UNITED STATES PATENT AND TRADEMARK OFFICE

Office Action Summary

10/811,568

MOUNTJOY, RICK

Killen (U.S. Publication No. 2004/0128948)

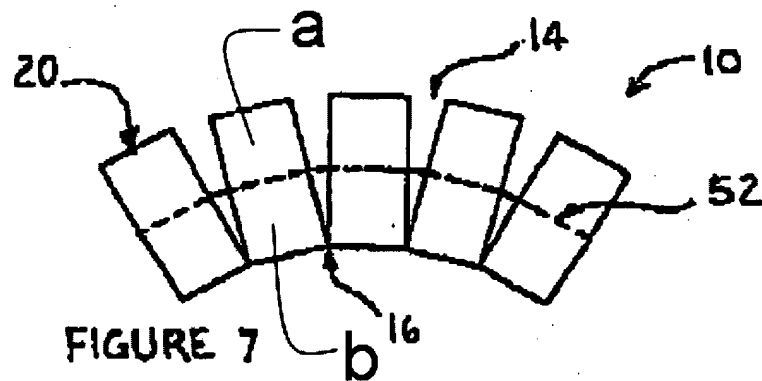
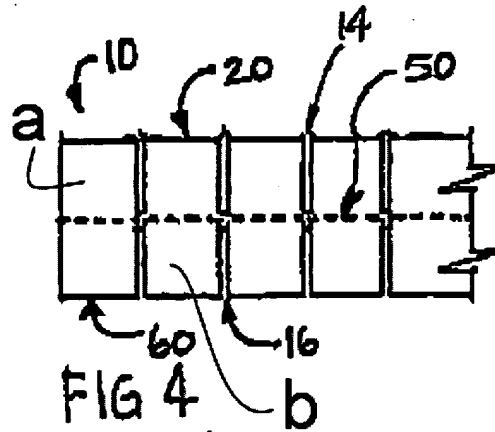
Regarding claim 8, Killen in Figure 4 discloses a construction element comprising a flexible element (50) having a first surface (surface of 50 adjacent to "a" and 20); and a first block element (a) and a second block element (20), the first and second block

Regarding claim 15, Killen in Figure 4 discloses a construction element comprising a flexible element (50) having a first surface (surface of 50 in contact with "a" and 20); and a first block element (a) and a second block element (20), the first and second block elements attached to the first surface of the flexible element with a space (14) between the first and second block elements; and a spacer (cables, rods, etc. on Pg 5, Par 101) disposed between the first and second block elements.

Regarding claim 21, Killen in Figure 7 discloses a construction element comprising a flexible element (52) having a first surface (upper surface of 52 adjacent to "a" and 20), the flexible element having a curve, a first block element (a) and a second block element (20), the first and second block elements attached to the first surface of the flexible element with a space (14) between the first and second block elements; and a spacer (cables, rods, etc. on Pg 5, Par 101) placed between the first and the second

Regarding claim 29, Killen in Figure 4 discloses a construction element comprising a flexible element (50) having a first surface (upper surface of 50 in contact with "a" and 20) and a second surface (lower surface of 50 in contact with 60 and "b"); a first block element (a) and a second block element (20), the first and second block elements (a, 20) attached to the first surface of the flexible element with a space (14) between the first and second block elements; a spacer (cables, rods, etc. on Pg 5, Par 101) disposed between the first and the second block elements; and a third block element (60), the third block element attached to the second surface of the flexible element (50). Furthermore, the method set forth in claims 23 and 25 would be inherent in constructing the structure set forth above.

Regarding claim 30, Killen in Figure 4 discloses a construction element as discussed above and further discloses a fourth block element (b), the third and fourth block element attached to the second surface of the flexible element (50) with a space (16) between the third and the fourth block element.
